Agenda Item 05

Supplementary Information Planning Committee on 14 February, 2018

Case No. 17/4747

Location	Land rear of 12-14 St Andrews Avenue, St Andrews Avenue, Wembley
Description	Erection of 3 two storey detached dwellinghouses to rear of 12 and 14 St Andrews Avenue, with provision for 4 car parking spaces, cycle and bin storage, installation of new service road between 12 and 14 onto St Andrews Avenue and associated landscaping

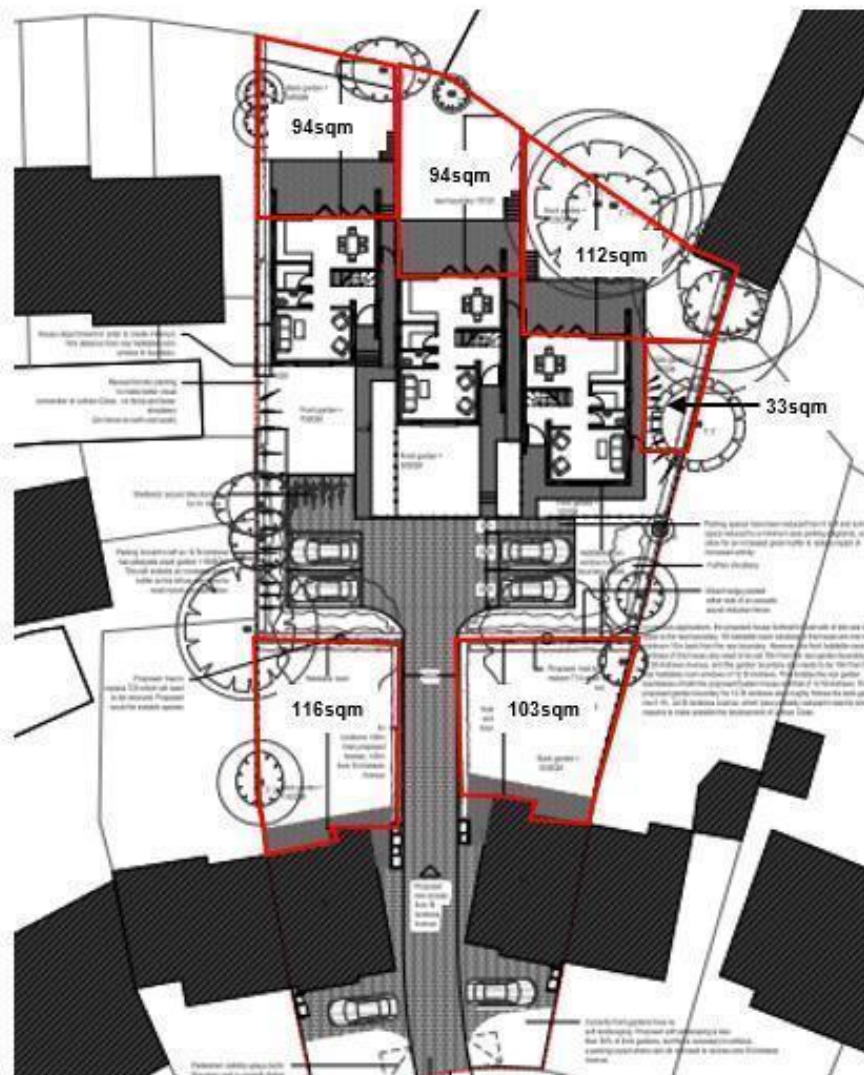
The Proposed Site Plan is annotated to show garden sizes and these are as follows:

House 1: 94sqm rear garden, 75sqm front garden
 House 2: 94sqm rear garden, 50sqm front garden
 House 3: 112sqm rear garden, 33sqm side garden, 31sqm front garden
 (The rear gardens include patios which are partly set in above the first floor)
 No 12 St Andrews Avenue: 103sqm rear garden
 No 14 St Andrews Avenue: 116sqm rear garden

See diagram below for rear garden layouts. These all exceed the required 50sqm for 3bed and larger properties.
